Ford Explorer Model year: 1994-1996 Engine: 4.0 litre V6 OHV

Coolant temperature indicator / Noises from the engine bay

Bulletin

Fig. 1

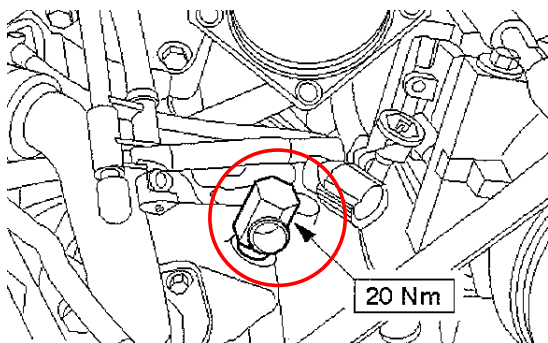
- Remove the cover from the throttle body, remove the two screws for this purpose (Fig. 1)
- Pull the plug off the intake air temperature sensor
- Remove the air induction pipe and throttle body
- Pull the plug off the coolant temperature sensor and remove the sensor (Fig. 2)
- Screw the distributor adapter (from the bypass kit) into the bore hole of the coolant temperature sensor (drawing 1)
- Connect the coolant sensor (drawing 2, pos. 1) with the rear muff of the distributor adapter
- Attach the reducer adapter (from the bypass kit) to the front muff on the distributor adapter (drawing 2, pos. 2)
